Application Number: SSI 15_7400

I writing in respect of the proposed Chatswood to Sydenham metro line.

Figure 6-2g Indicative Chatswood to Sydenham alignment plan and long section

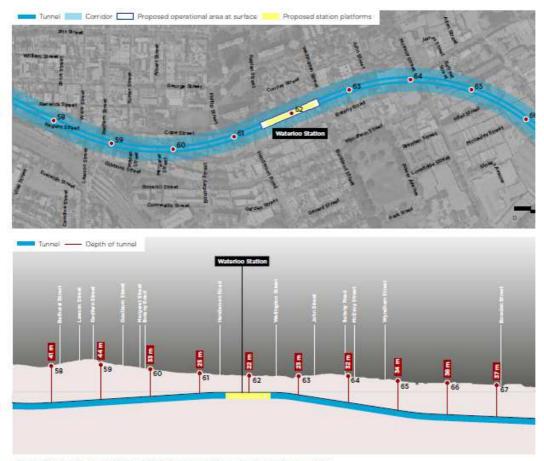
At this location, the depth of the tunnel is 25 metres as shown at point 61 on page 129 of the EIS:

Waterloo Station is the second shallowest station (behind Pitt Street) on the line and this section of the tunnel is closer to the surface than the vast majority of the 16.5km track. The only shallower parts occur in the CBD and on approach to the "dives".

In this location it is only proposed to have "standard attenuation" in one direction and "high attenuation" in another. As both tracks run under the same buildings I am not sure why they have different attenuation methods.

This is concerning because immediately above this section is medium density residential development. At this depth there is no doubt that vibration from the operating trains will be felt and cause noise disturbance and possibly structural damage. I can feel the vibration from the Airport line which is some distance away on George Street.

Due to the shallow depth of the proposed tunnel and the medium density residential use directly above, **this section of the track must have "very high attenuation"** to avoid negative impacts to the residents. Anything less would be simply cost cutting at the expense of the existing residents.
